Addendum Date: May 14, 2026
CITY OF PENSACOLA, FLORIDA
BID NO. 26-034

WAYSIDE PARK EAST AND 17TH AVENUE PARK IMPROVEMENTS

ADDENDUM #1

Overall Scope Graphic

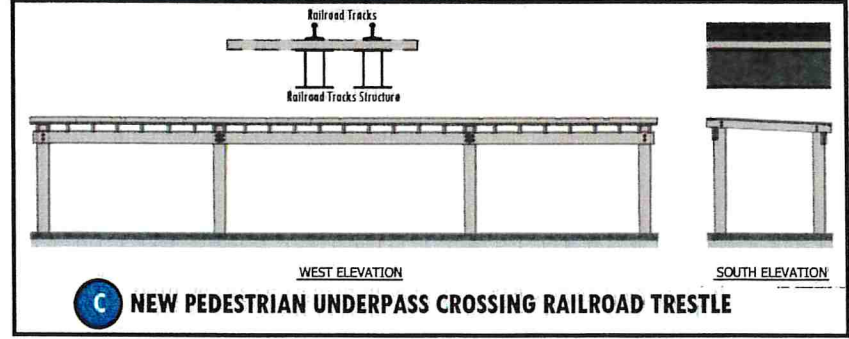
3. An engineering estimate of probable construction cost is attached with the A1 documents concurrent with this Addendum.
4. **The scope of work has been revised to include Alternative #4 for Green-Tinted sidewalks.** This alternative replaces the standard gray sidewalks bordering the parking lot with green-tinted ones for aesthetic appeal. These green sidewalk locations are shown on the attached *OVERALL SITE GRAPHIC*.
